## FORD 4R44E/55E AND 5R44E/55E FLAIRED SHIFTS AND/OR GEAR RATIO ERROR CODES

## THROTTLE KIT INSTALLATION

Figure 1

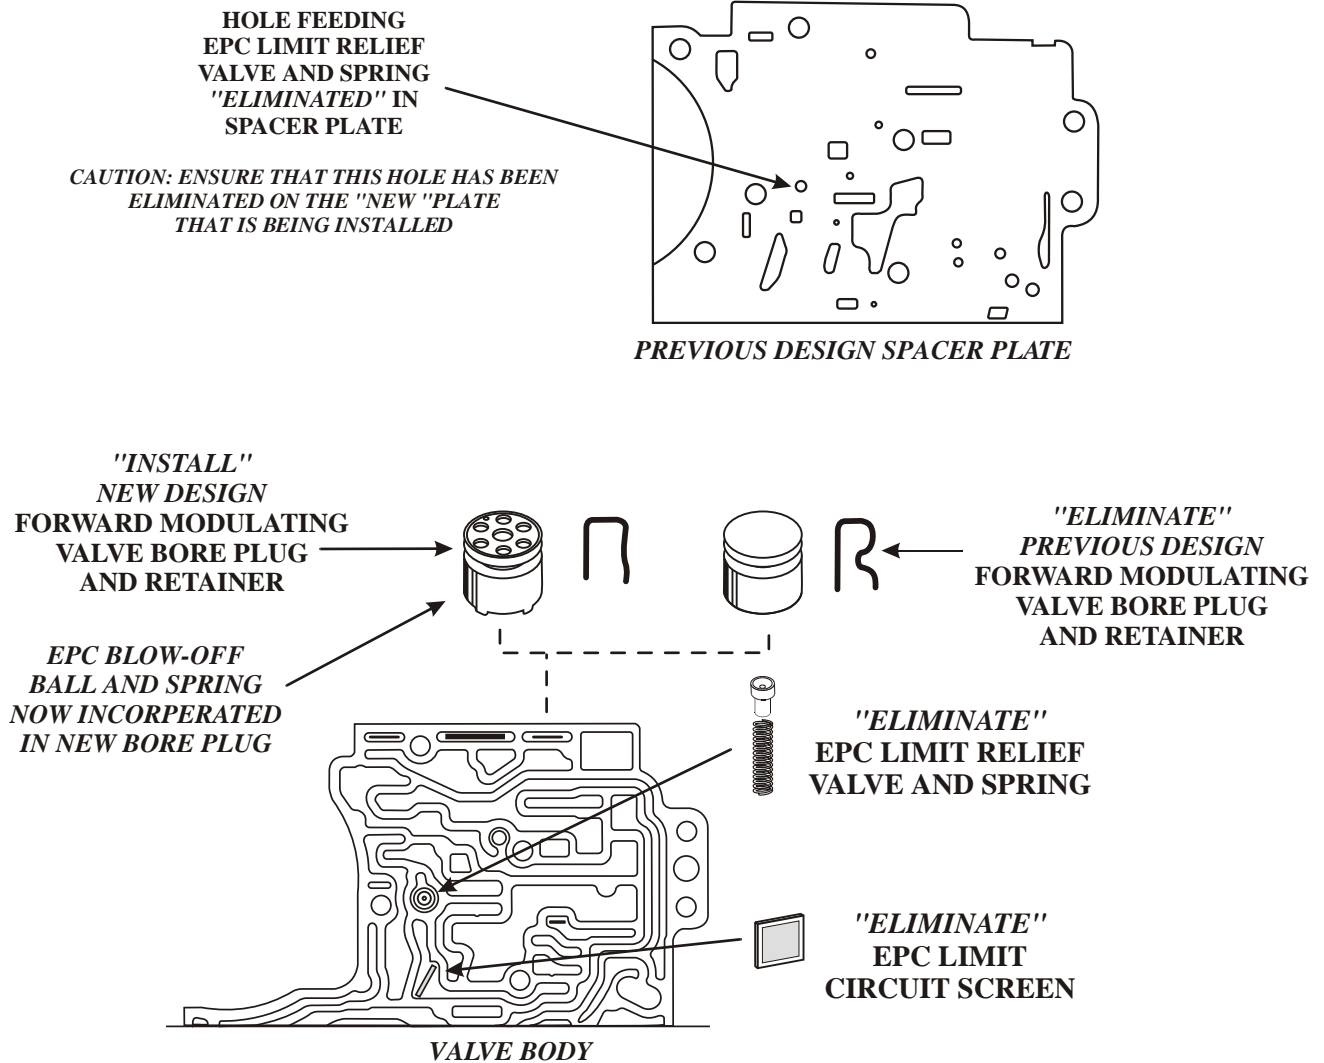
**COMPLAINT:** Before and/or after overhaul, 1995-2002 vehicles equipped with the 4R44E/55E or 5R44E/55E transmissions, may exhibit soft or flaired shifts as well as multiple gear ratio errors.

**CAUSE:** The cause may be, insufficient pressure rise.

**CORRECTION:** To correct this condition, install the "Throttle Kit" as shown below and in Figure 1. This new service kit **requires** the use of a "**new**" spacer plate with the EPC blow-off hole eliminated, as per Ford Motor Company bulletin number 02-13-8, and shown in Figure 1.

- (1) Remove and discard the bore plug and retaining clip from the Forward Modulating Valve bore, as shown in Figure 1.
- (2) Install the new design bore plug and retaining clip in the Forward Modulating Valve bore, as shown in Figure 1. The new design bore plug now incorporates the EPC blow-off ball and spring, as shown in Figure 1.
- (3) Remove and discard the previous design EPC ball and spring from its location in the valve body, as shown in Figure 1.
- (4) Remove and discard the EPC limit screen from its location in the valve body, as shown in Figure 1.
- (5) Install a **new** spacer plate, available from Ford Motor Company, that has hole number 50 eliminated, as shown in Figure 1. Refer to Figure 2 to choose the proper spacer plate to ensure the correct calibration for the vehicle that you are working on.

***Special Note: Inspect the new spacer plate to ensure that the hole has been eliminated, before you install it on valve body.***
